# TOWN OF PLAINFIELD PLAN COMMISSION

**CASE NO.:** [RZ-26-019](#)

**Project Page:** Daum Farms Development

**REQUESTED ACTIONS:** Zone Map Amendment of approximately 28.5 +/- acres from AG: Agriculture to RF: Residential Flex.

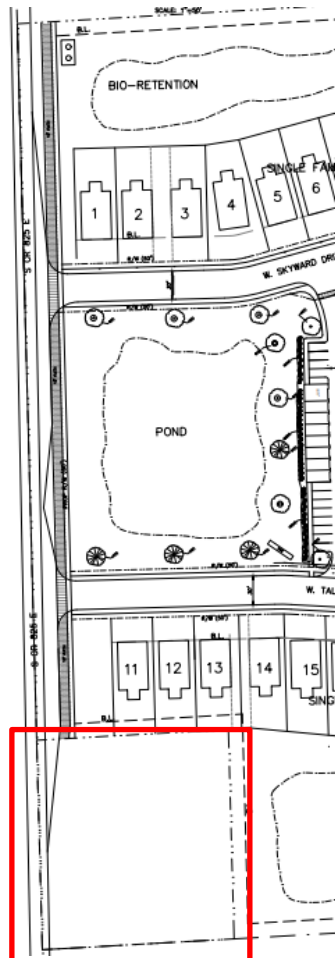
Very little site landscaping has been included in the single family portion of this proposed development. No street trees have been included along Talon Way or Skyward Drive, both streets to receive public designation. It also appears that no landscaping has been provided for along S CR 825 E at the entrance to the property.

Additionally, it appears as though very little to no landscaping has been provided for where single-family lots are adjacent to neighboring residential properties. The image on the left shows the proposed landscaping along S CR 825 E. This image also shows where the proposed development will share an immediate property line with a residential property (existing residential highlighted in red on left).
